PUBLIC NOTICE NO. 76FL0037D

PUBLIC NOTICE OF NPDES PERMIT DETERMINATIONS

Company: Gulf Power Company
Location: Scholz Steam Plant, Chattahoochee, Florida 32324
NPDES Permit No. FL0002283
Permit Effective Date: February 16, 1976
Prior Public Notice No.: 76FL0037
Prior Public Notice Date: October 30, 1975

GULF POWER COMPANY
SCHOLZ STEAM PLANT UNITS 1 & 2
WASTE TREATMENT PLAN

SUBJECT **SCHOLZ STEAM PLANT**
 DETAIL **CLEAR WATER, STEAM & FEEDWATER CIRCULATION**
 SCALE **NONE** SH 1 OF 1 SHEETS
 A-3832

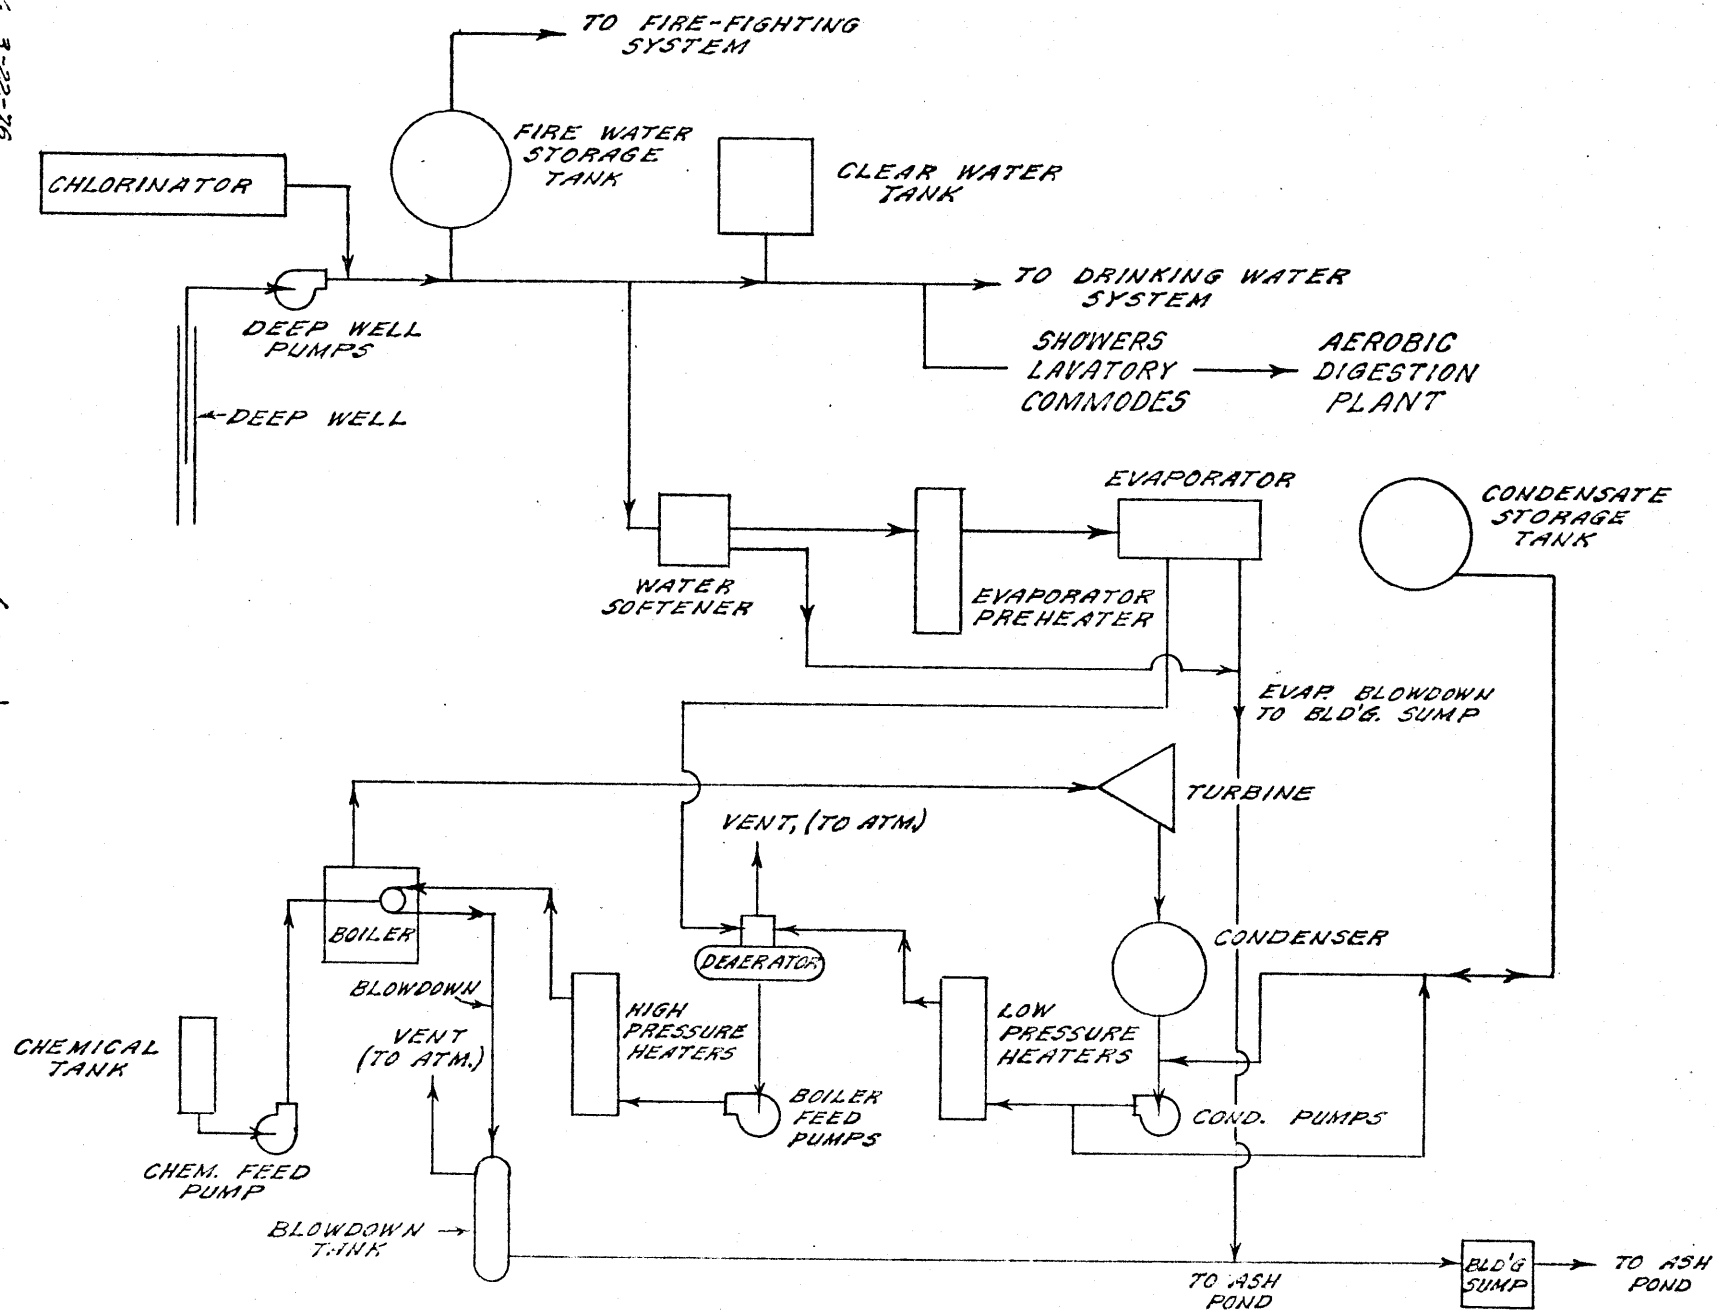
Each of us has recently received copies of proposed chemical waste treatment plans. Do you believe the proposal is adequate to provide satisfactory treatment? I would appreciate having your opinion on this. Thanks in advance.
